**NEI 09-10 [Rev 1a-A]**

# **Guidelines for Effective Prevention and Management of System Gas Accumulation**

**April 2013**

SUBJECT: FINAL SAFETY EVALUATION OF NUCLEAR ENERGY INSTITUTE TOPICAL  
REPORT NEI 09-10, REVISION 1a, "GUIDELINES FOR EFFECTIVE  
PREVENTION AND MANAGEMENT OF SYSTEM GAS ACCUMULATION"  
(TAC NO. ME5291)

**Figure 1 - Data Plot taken from Reference 2**

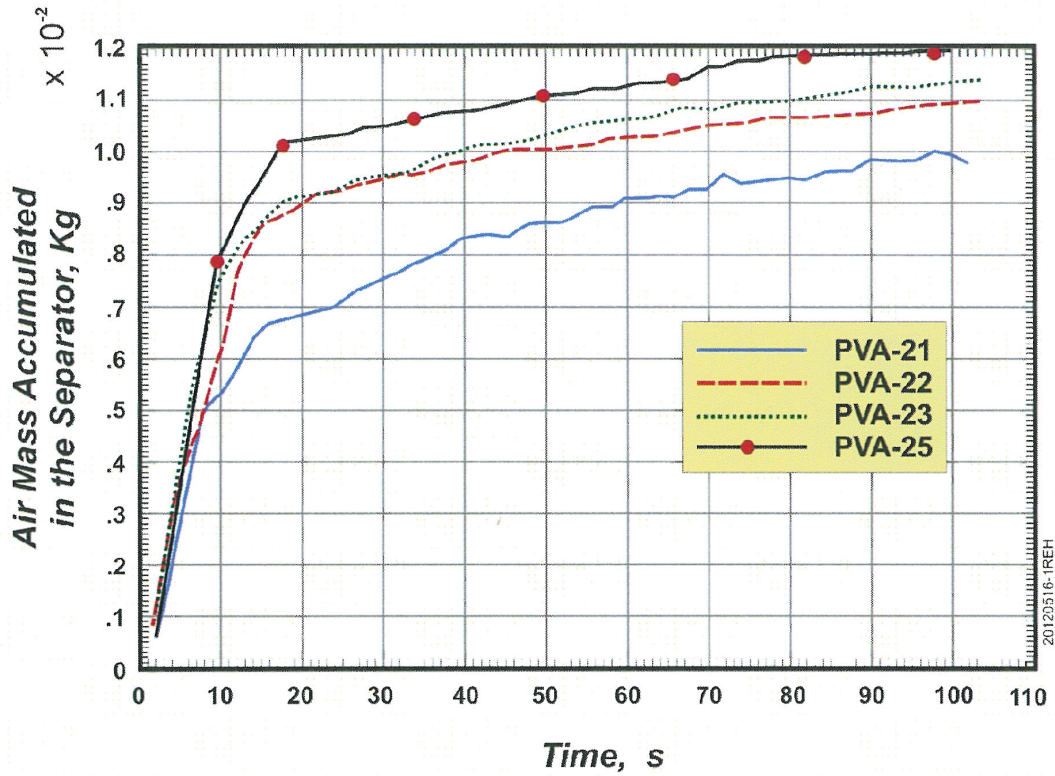
**Reference 2's Figure B-3 provides void fraction at the bottom of the downcomer as a function of time for Test PVA22. This starts at 0, maximizes at about 0.21, and the transient is over in about 30 seconds. Yet the void fraction remains at about 0.02 for the remainder of the plot that ends at 120 sec. Figure 9 provides the same information for Test PVA21 where the behavior is similar although the maximum void fraction is about 0.13, and void fraction is zero after about 30 seconds. Table B-1 does not identify any difference between the tests. The NRC staff does not understand the Figure B-3 non-zero behavior since the void source is finite unless for some reason the void is circulating in the bottom of the downcomer. Figure B-4 is stated to provide a comparison of gas transport to the pump compared to the initial gas inventory and may provide some insight, but the figure in the NRC staff's copies of the report is a solid black rectangle and provides no information.**

Since these were similar tests, the results were also similar, i.e. essentially all the gas accumulation in the lower header was discharged down the HPSI suction line and caught in the gas separator. Figure 1, below, is taken from the test report and shows the measured gas accumulation in the separator with PVA-21 having a lower amount of gas than PVA-22. Hence, this information demonstrates that there was more gas transported in test PVA-22. How is this possible when the initial conditions were virtually the same? The answer lies in the fact that there were segments of the experiment that had to be pressurized to achieve the scaling needed for representation of the reactor system. One of these was the sump tank that is identified in Figures B-1 and B-2 in FAI/09-130. When the sump water is pressurized by a non-condensable gas, in this case nitrogen, the gas will begin to dissolve in the water mass and the fact that the water is circulated increases the rate of dissolution. The sump tank pressure used for both of these experiments was 15.8 psig and the repeated exposure to this pressure forced more gas into solution with some of the gas exiting solution as the flow transient progressed. The region for greatest potential to have gas exit solution is that region which experiences the most acceleration and this is likely as the flow passed through the check valve at the top of the downcomer. Gas coming out of solution will continue over a longer time and act to manifest itself as a greater gas accumulation in the gas separation volume which

As illustrated in Figure 1, the long term slope of the accumulation in gas separator has a value of approximately 0.002 kg accumulated over 100 seconds, i.e. a rate of  $2 \times 10^{-5}$  kg/sec. The gas solubility tables given in the 40th Edition of the Handbook of Physics and Chemistry give a value of 18.68 cc of air dissolved in 1 liter of water at 20°C, with an overpressure of 760 mm Hg. Since the overpressure of the containment sump was 15.8 psig, this pressure above 1 atm characterizes the extent of additional gas that could be dissolved in the containment sump water. Given that the flow through the downcomer over the long term was approximately 60 gpm, the flow through the check valve and downcomer was 0.134 ft<sup>3</sup>/sec (3.8 l/sec). With the imposed overpressure, the additional gas dissolved would have the potential for approximately 35 cc/sec to exit solution (71 cc/sec at one atmosphere), and considering the density of air at two atmospheres to be 2.4 kg/m<sup>3</sup>, would result in an accumulation rate of  $8.4 \times 10^{-5}$  kg/sec in the separator. Hence, the potential for gas to dissolve and exit solution in the check valve gives a larger accumulation rate than the measured value, suggesting that either the water in the sump tank was not yet saturated with nitrogen or not all of the additional gas exited solution. The fact that successive tests demonstrate increasing gas accumulations is also consistent with increasing dissolution and exiting from solution. Consequently, it is our conclusion that this gas exiting solution is the mechanism responsible for this longer term difference in the measured pressure response for the static head representation of the void fraction between the two experiments.

**Figure 2 - Comparison of the Gas Transport toward the Pump Compared to the Initial Gas Inventory in the High Point**

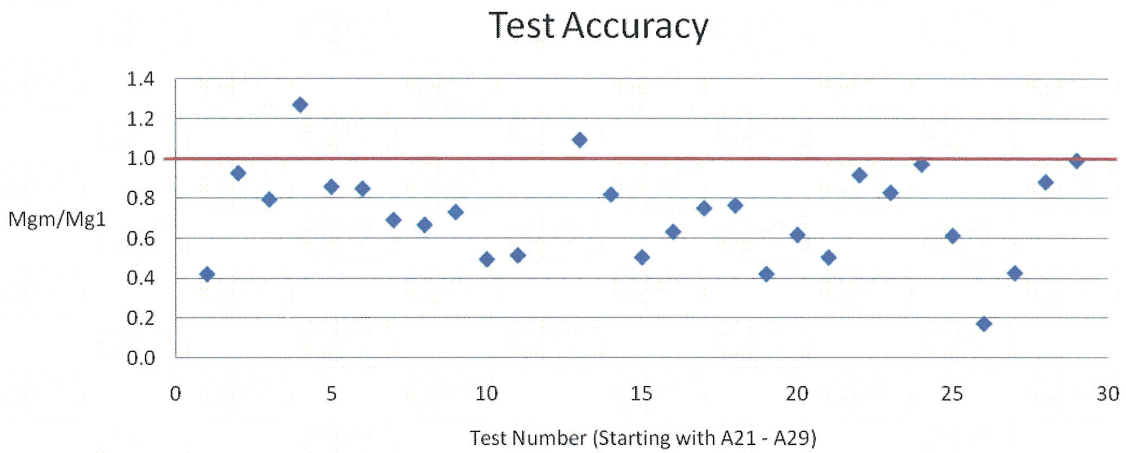
- (a) Explain the differences, and**
- (b) provide a legible Figure B-4.**

With respect to item (b) a legible copy of Figure B-4 is provided below (see Figure 2).
